Informational Bulletin

Bulletin No: C-017-06

Grass Catcher

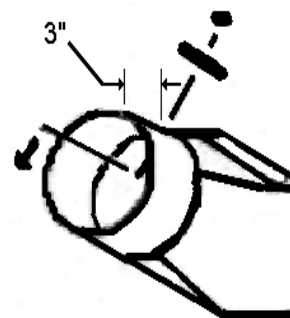
Bag Catcher flexible hose interfering with tire in some cases.

Relocate the hose clamp mounting bolt center to 3" from hose end of chute.
See Drawing.
